STATE OF FLORIDA
DEPARTMENT OF ENVIRONMENTAL PROTECTION
NOTICE OF FINAL AMENDED PERMIT

DEP File No. AC53-260190
PSD-FL-222
Polk County

Final Determination
US Agri-Chemicals Corp.
Fort Meade, Florida

Prilled Monoammonium Phosphate (MAP) Plant
PSD-FL-222 (AC53-260190)

Figure 6. NTU vs. pressure loss. L/G and V_c are taken as parameters. $T_{ce} = 60^\circ\text{C}$ and $L_v/D_c = 8.5$.

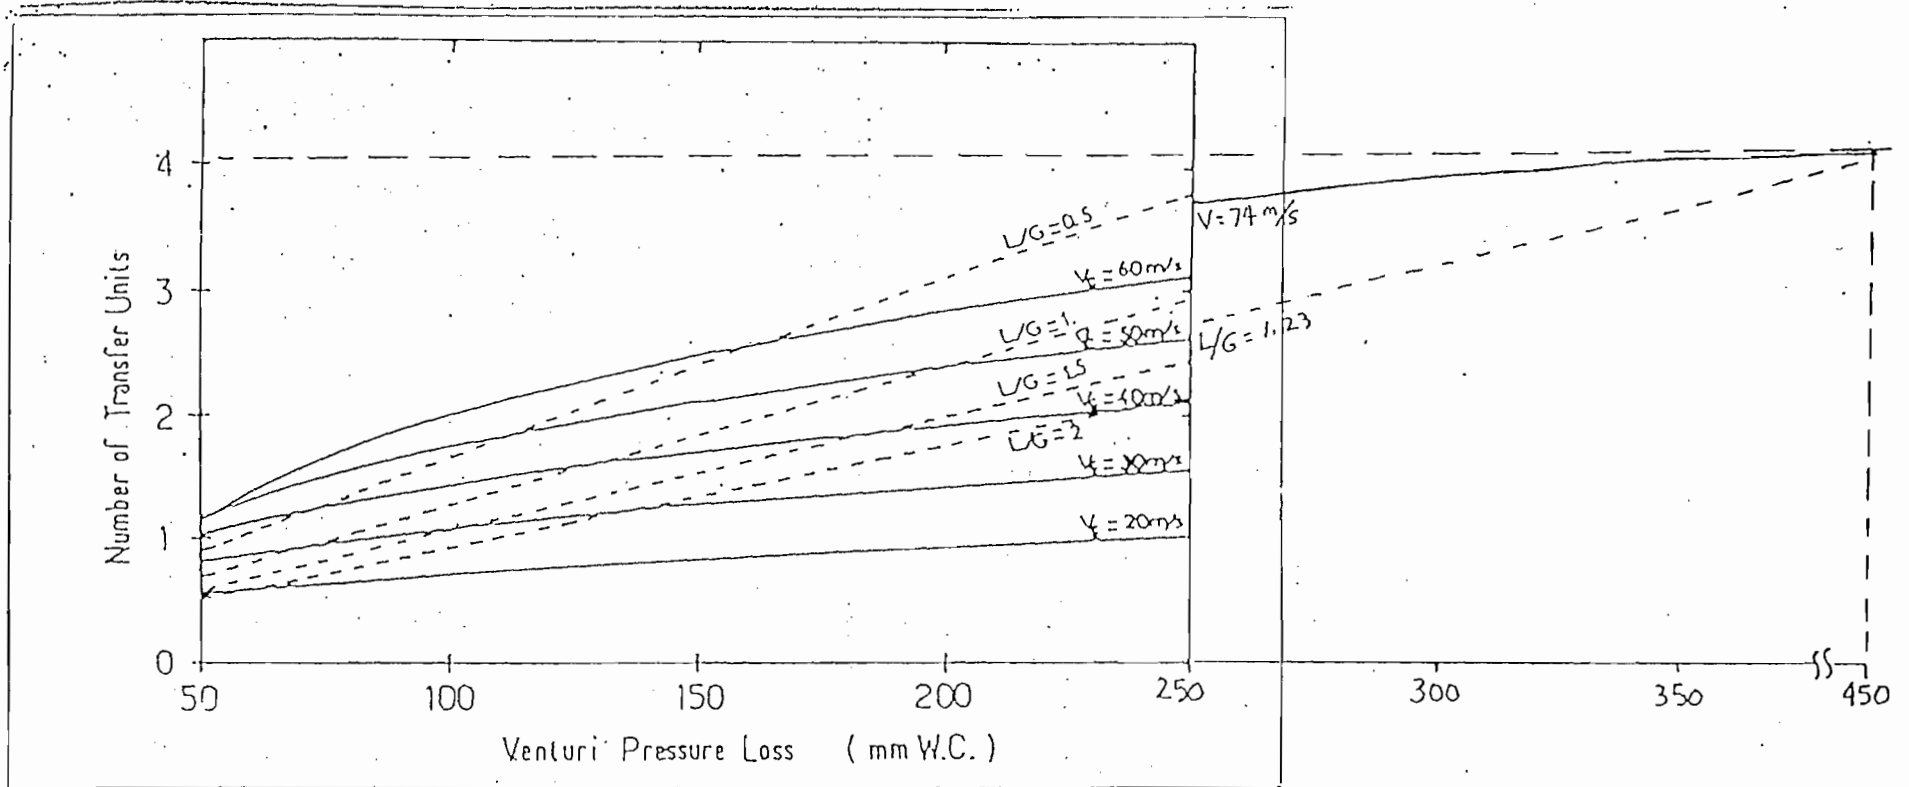
The Jacobs calculations are incorrect because of two improper assumptions. The extrapolated curve that Jacobs drew on Figure 5 of the article is not relevant for their unneutralized scrubbing water. Secondly, the data in Figure 5 cannot be infinitely extrapolated at constant L/G because the short contact time in the venturi throat prevents the mass transfer from increasing beyond a certain gas velocity.

Attached is an extrapolation performed on Figure 6 which shows the variation of transfer units with the same variables as in Figure 5 but with pressure drop added. As shown, a maximum of 4.0 transfer units is obtained for the conditions specified by Jacobs, again keeping in mind that this is applicable only for neutralized water. The highest actual test result reported was 3.6 NTU with neutralized water, therefore, the Department's 2.7 NTU estimate is reasonable for the high-solids scrubbing slurry Jacobs has proposed.

Figure 6. NTU vs. pressure loss. L/G and V_c are taken as parameters. $T_{CE} = 60^\circ\text{C}$ and $L_v/D_c = 8.5$.

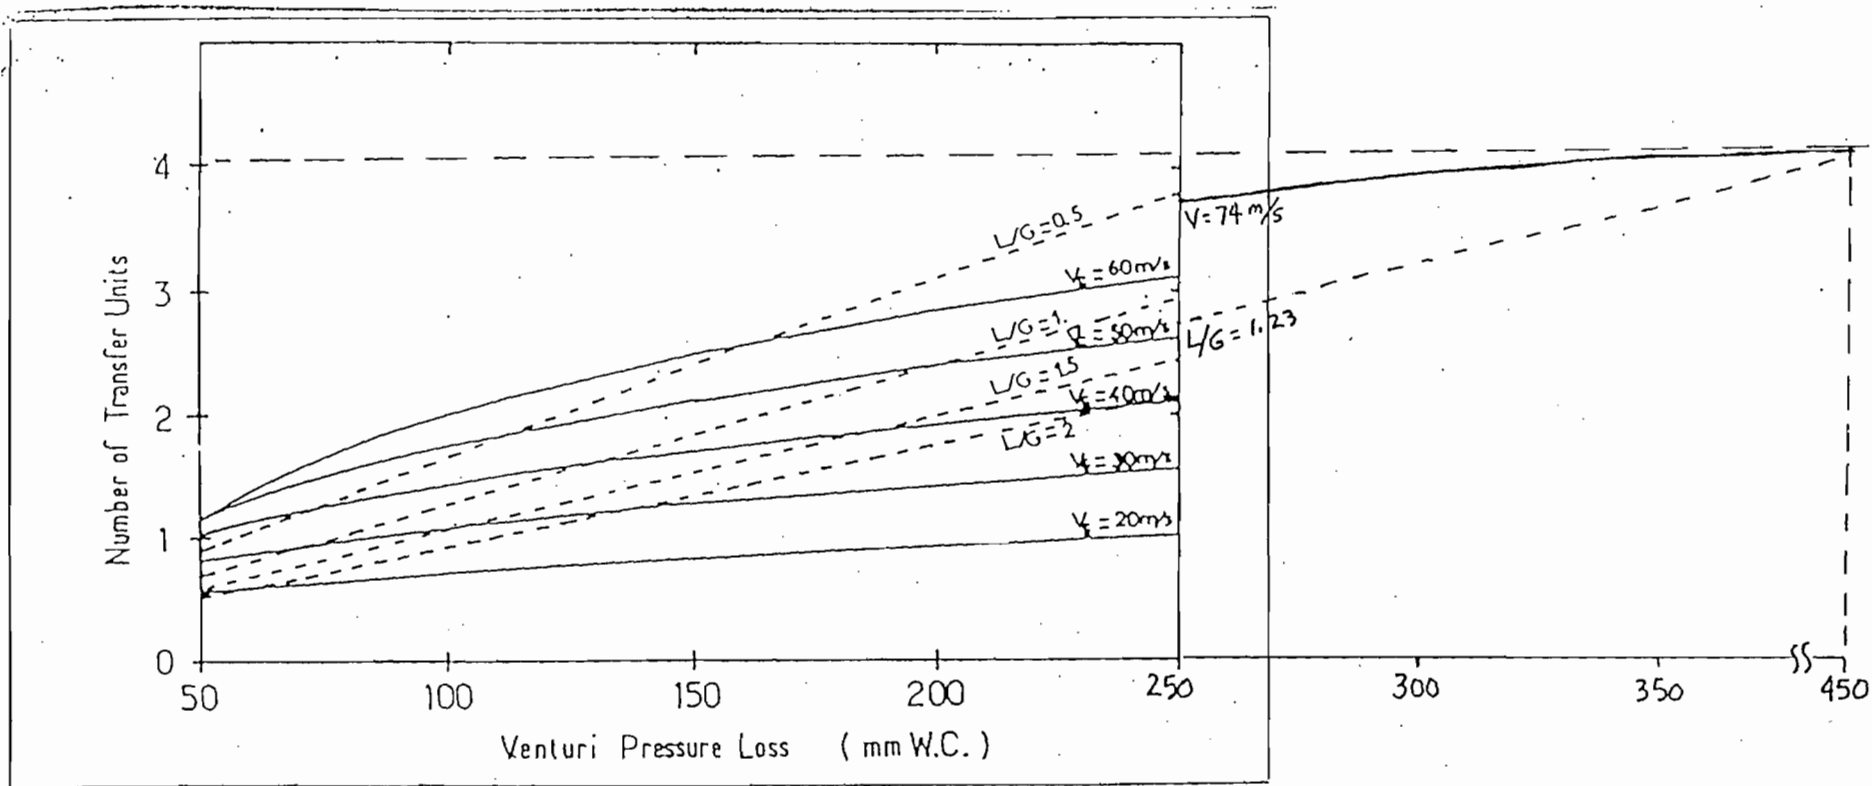
The Jacobs calculations are incorrect because of two improper assumptions. The extrapolated curve that Jacobs drew on Figure 5 of the article is not relevant for their unneutralized scrubbing water. Secondly, the data in Figure 5 cannot be infinitely extrapolated at constant L/G because the short contact time in the venturi throat prevents the mass transfer from increasing beyond a certain gas velocity. Attached is an extrapolation performed on Figure 6 which shows the variation of transfer units with the same variables as in Figure 5 but with pressure drop added. As shown, a maximum of 4.0 transfer units is obtained for the conditions specified by Jacobs, again keeping in mind that this is applicable only for neutralized water. The highest actual test result reported was 3.6 NTU with neutralized water, therefore, the Department's 2.7 NTU estimate is reasonable for the high-solids scrubbing slurry Jacobs has proposed.

Figure 6. NTU vs. pressure loss. L/G and V_c are taken as parameters. $T_{ce} = 60^\circ\text{C}$ and $L_v/D_c = 8.5$.

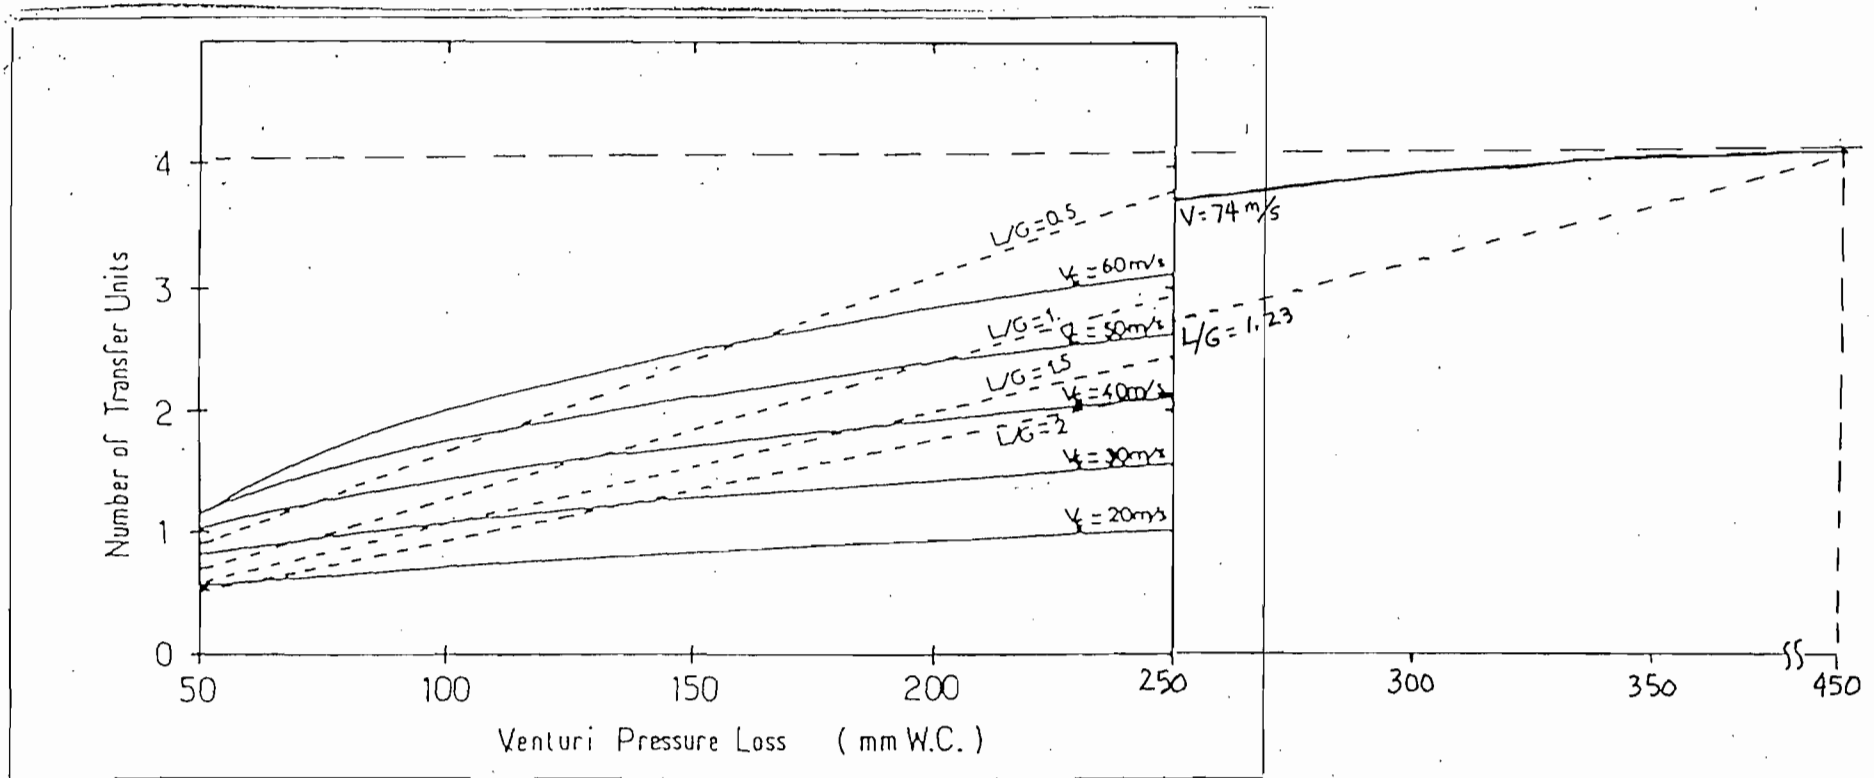
The Jacobs calculations are incorrect because of two improper assumptions. The extrapolated curve that Jacobs drew on Figure 5 of the article is not relevant for their unneutralized scrubbing water. Secondly, the data in Figure 5 cannot be infinitely extrapolated at constant L/G because the short contact time in the venturi throat prevents the mass transfer from increasing beyond a certain gas velocity. Attached is an extrapolation performed on Figure 6 which shows the variation of transfer units with the same variables as in Figure 5 but with pressure drop added. As shown, a maximum of 4.0 transfer units is obtained for the conditions specified by Jacobs, again keeping in mind that this is applicable only for neutralized water. The highest actual test result reported was 3.6 NTU with neutralized water, therefore, the Department's 2.7 NTU estimate is reasonable for the high-solids scrubbing slurry Jacobs has proposed.

Figure 6. NTU vs. pressure loss. L/G and V_c are taken as parameters. $T_{CE} = 60^\circ\text{C}$ and $Lv/Dc = 8.5$.

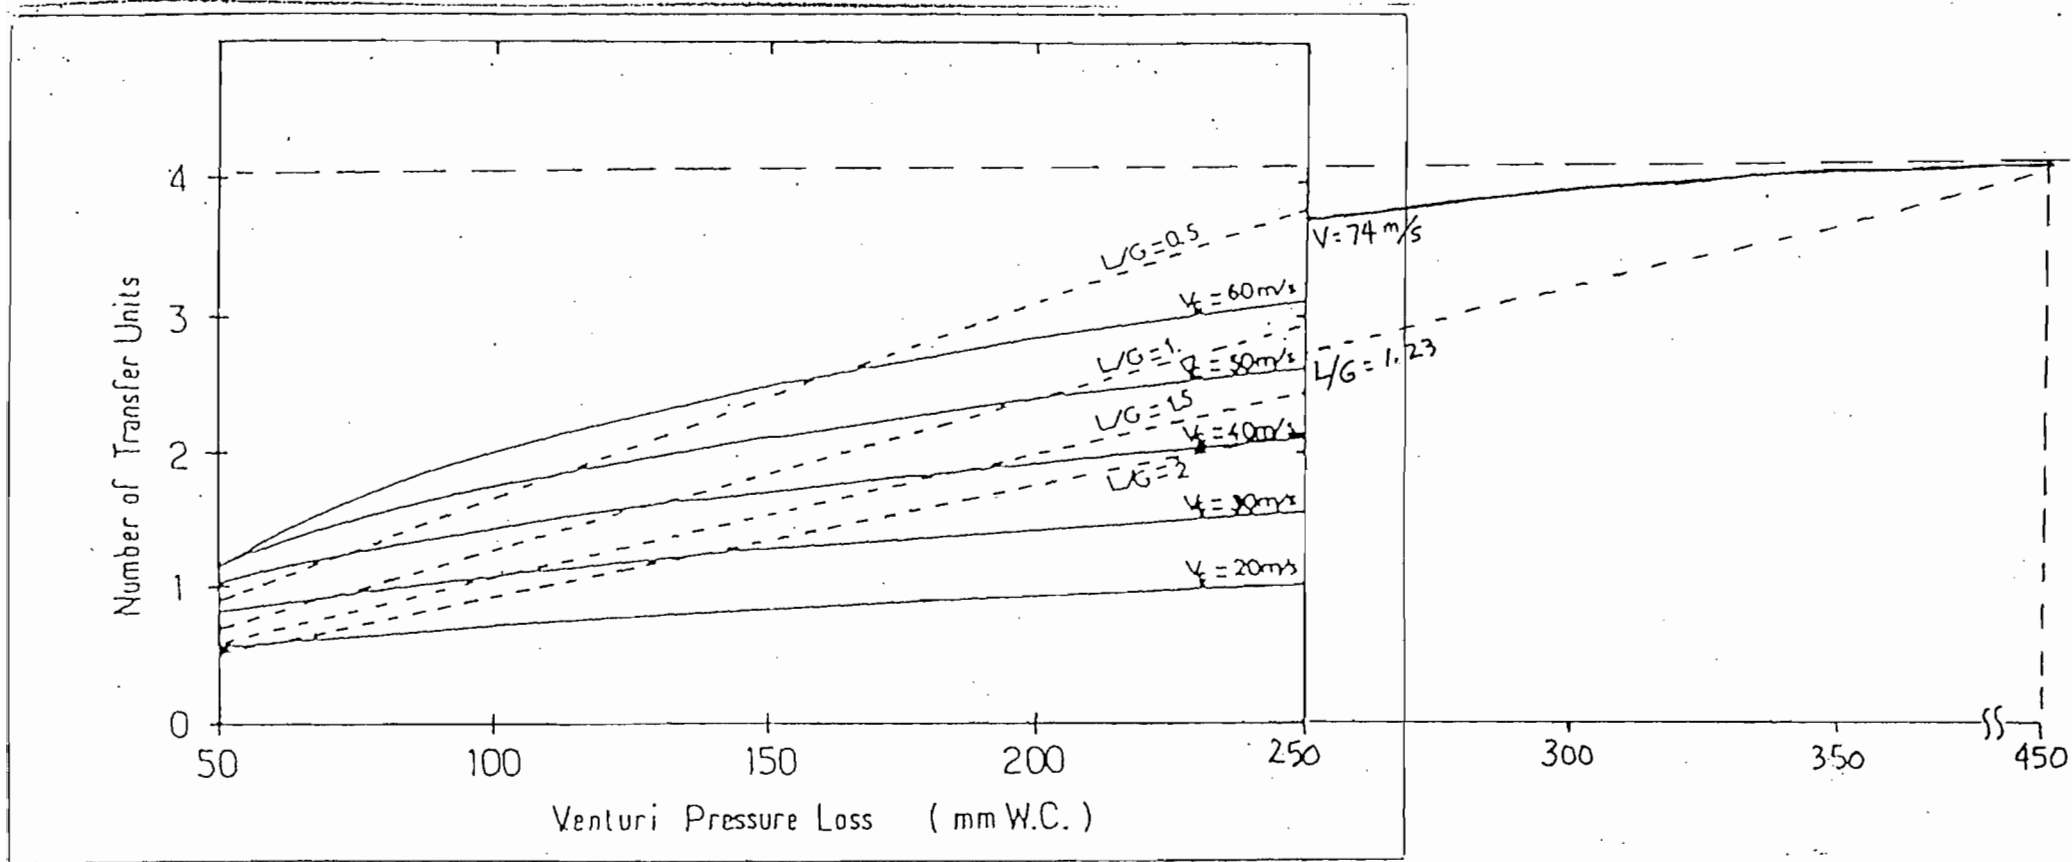
The Department cannot agree with these latest calculations submitted by Jacobs. The extrapolated curve that Jacobs drew on Figure 5 of the article is not relevant for their unneutralized scrubbing slurry. Secondly, the data in Figure 5 cannot be infinitely extrapolated at constant L/G because the short contact time in the venturi throat prevents the mass transfer from increasing beyond a certain gas velocity.

Attached is an extrapolation performed on Figure 6 which shows the variation of transfer units with the same variables as in Figure 5 but with pressure drop added. As shown, a maximum of 4.0 transfer units is obtained for the conditions specified by Jacobs, again keeping in mind that this is applicable only for neutralized water. The highest actual test result reported in the article was 3.6 NTU with neutralized water, therefore, the Department's 2.7 NTU estimate is reasonable for the high-solids scrubbing slurry Jacobs has proposed.

Figure 5. Variation of NTU with L/G ratio and V_g calculated from the empirical law. Using $T_{in} = 60^\circ\text{C}$ and saturated gases; $L_v/D_c = 8.5$.

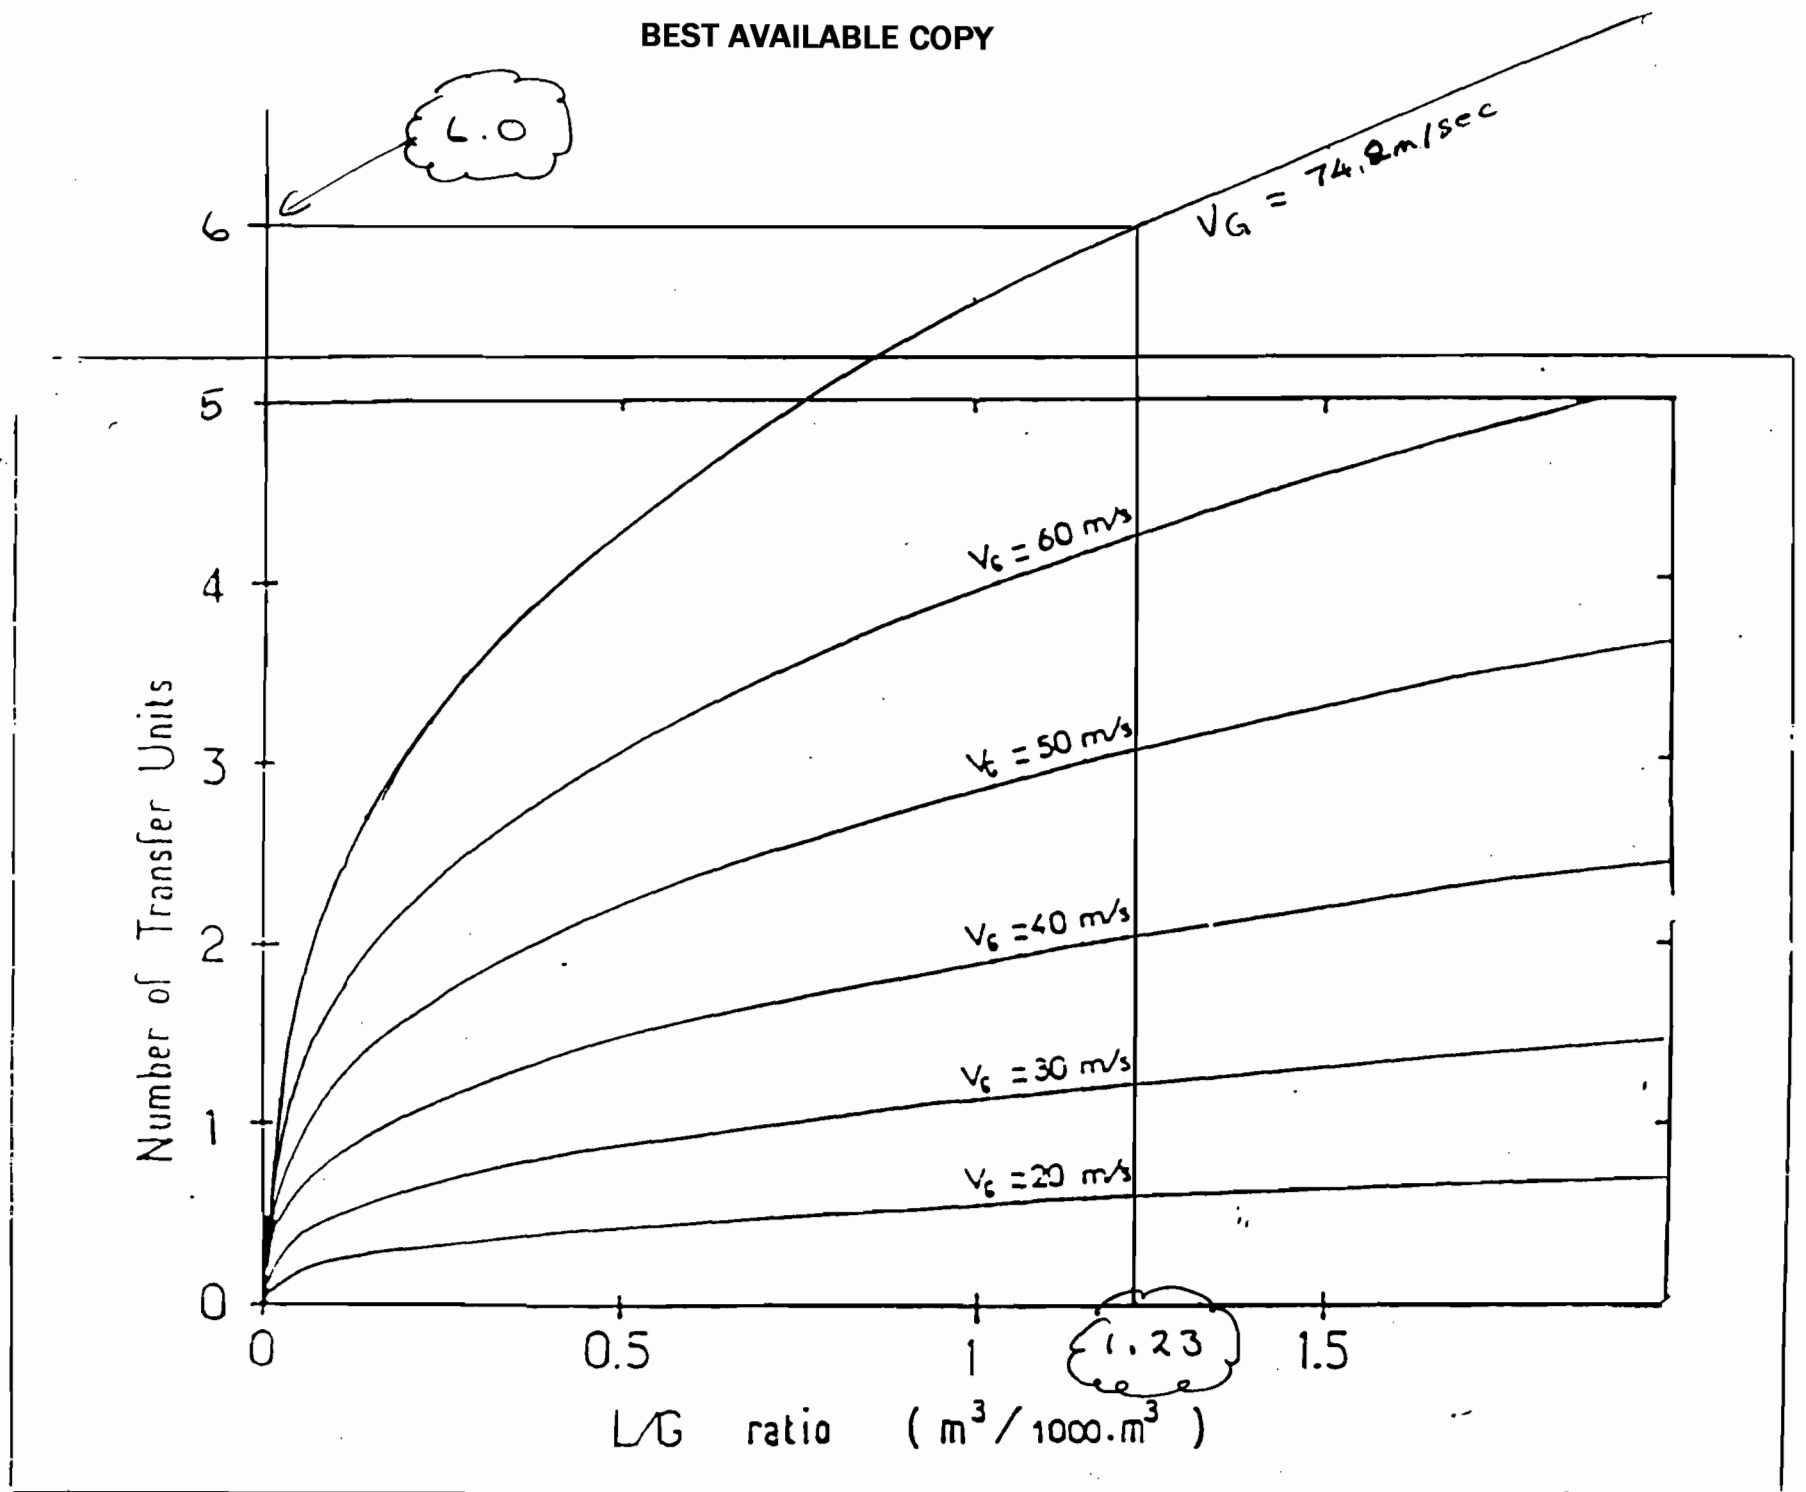
Figure 5 of this article shows the number of transfer units at five for a throat velocity of 60 meters per second and a liquid to gas ratio ($m^3/1,000m^3$) of 1.9. Our specification (attached) shows a pressure drop of 19 inches of water, an irrigation rate of 900 gpm and a gas flow of 97,626 acfm.

Using Figure 3 and Figure 5 of this article, these data correspond to a gas velocity in the throat of 74.5 meters per second, a liquid to gas ratio of 1.23 and six transfer units. This corresponds to an approach to equilibrium at 1.7% of the equilibrium vapor concentration
